Department of Transportation

MEMORANDUM

SUBJECT: ZC Case No. 15-27A – 300 Morse Street NE Building A2 Stage 2 PUD

Figure 1 Site Plan (Source: Applicant's CTR)

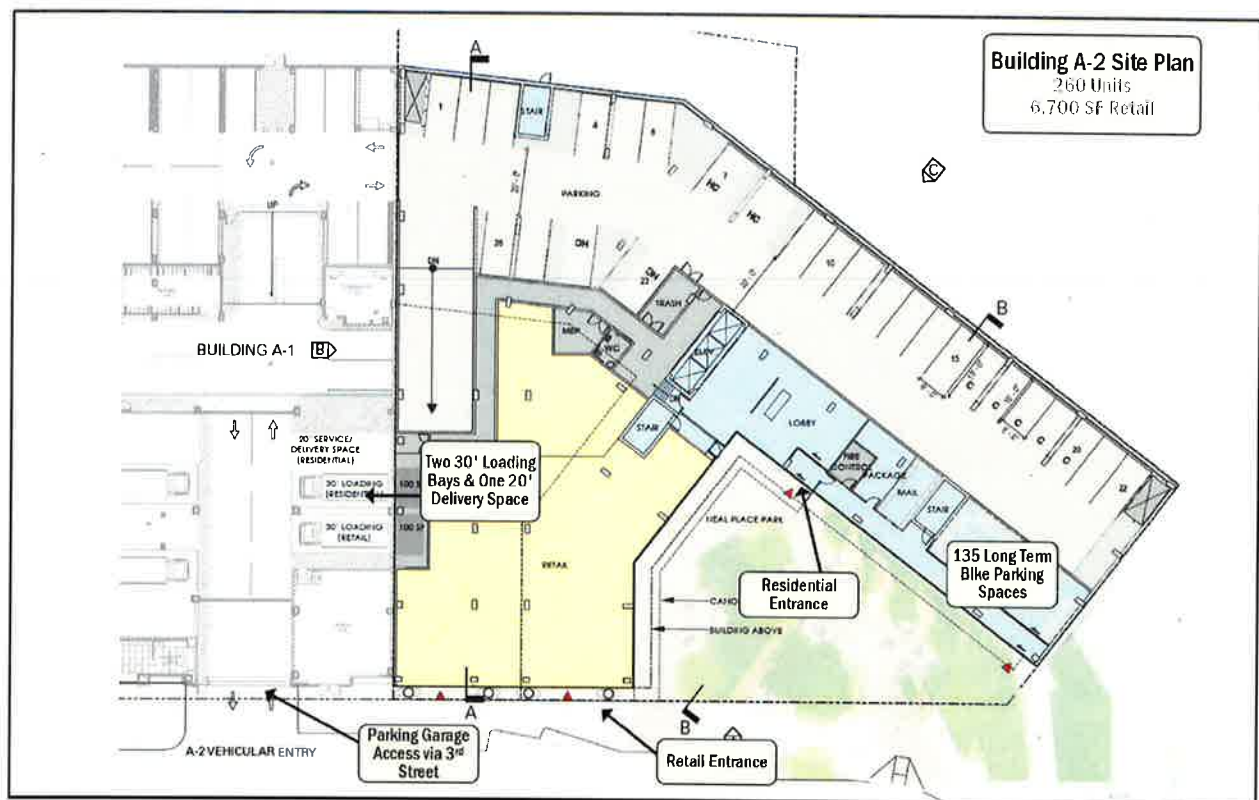
Consistent with the Stage 1 PUD approval, parking garage, loading, and trash access will be provided from a curb cut on private 3rd Street that will be shared with Building A1. Access to the two (2) 30-foot loading berths and one (1) 20-foot service delivery space is proposed via the curb cut. All truck

maneuvers will be accommodated with head-in/head-out maneuvers across public space consistent with DDOT standards. A site plan is shown in *Figure 1*.

The Stage 1 PUD plans identified one (1) 30-foot loading berth for the Building A2. The Applicant seeks to revise the site plan to include two (2) 30-foot loading berths and one (1) service delivery space. The Applicant anticipates approximately seven (7) to eight (8) daily truck deliveries including residential move-in/move-out, trash, mail/parcel, and commercial parcel deliveries per day. DDOT finds the number and size of proposed loading facilities to be appropriate. Of note, the berths would be located within Building A1, but the associated loading platforms would be located within A2.

Figure 3 Building A2 Streetscape Design (Source: Applicant)

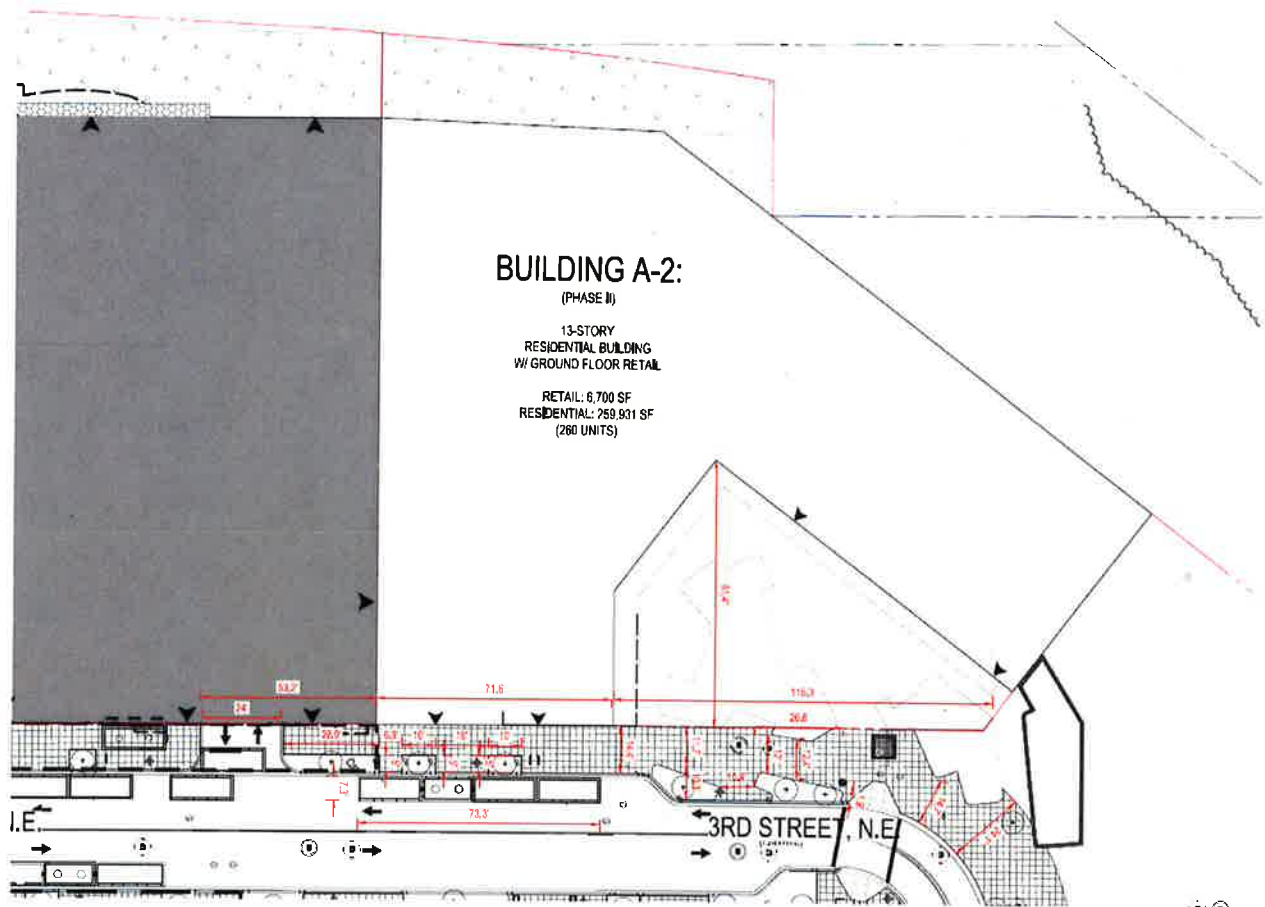
The Applicant proposes to improve the adjacent streetscape consistent with the Union Market Streetscape Guidelines. Due to the street network being private, the streetscape treatment for the public realm adjacent to Building A2 will be approved by the subject Stage 2 PUD review rather than through DDOT's public space permitting process. The streetscape plans are shown in Figure 3.
